Design Review Subcommittee (DRSC)

Minor Architectural Permit 15-268, Ocean View Plaza Escalator

<u>Modifications</u>, a request to consider covering four exterior escalators with stucco-finished walls to match the center's exterior, located at 638

Figure 3 – West Escalator Existing

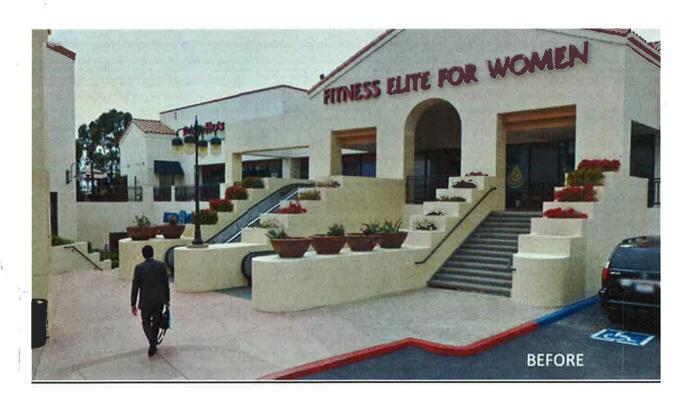
The proposed design to cover up the escalators does not follow basic principles of Spanish design. The existing stepped walls between the stairs and escalators serve to define and orient the pedestrian space. The proposed project, while tying into the existing design, detracts from the original site design because the walls would be transformed from site accent features into substantial structures. These structures will not increase "pedestrian circulation", provide "opportunities for outdoor activities", nor "define outdoor spaces" (II.6).

Instead, the covered escalators increase the perceived building mass of the shopping center, reduce the visual connection between pedestrians and the shops, and restrict the amount of useable open space. Additionally, on the west escalators, the new structure separates the pedestrian circulation route from the bottom to the top floor because the two remaining staircases would not be in close proximity to one another.

To increase the project's consistency with the basic principles of site design specified in the City's Design Guidelines, staff recommends that the applicant modify the proposal to consist of one of the following options (listed in descending order of staff preference):

- Install additional stairs. This option would involve the complete removal of the escalators and would include the removal of some of the walls that currently separate the escalators from the stairs. This option would maintain the ample pedestrian circulation that originally existed on the site by providing stairs where the escalators are now, and maintain a visually inviting and apparent path for shoppers.

- 2. Create new courtyard/ public spaces. This option would involve the complete removal of the escalators and associated walls. This would require that most of the affected areas be regraded, and that new hardscape and landscaping is installed to create open areas that can be used as additional outdoor restaurant seating or sitting areas. This option enhances the functionality of the site, providing additional public areas.

- 3. Install new landscaping. This option would involve the complete removal of the escalators and would include the removal of some of the walls that currently separate the escalators from the stairs. This would require that new hardscape and landscaping is installed to create stepping, landscaped planters near the existing grades of the escalators. This option reduces pedestrian access areas, but increases the site landscaping to help reduce the apparent building mass of the center.
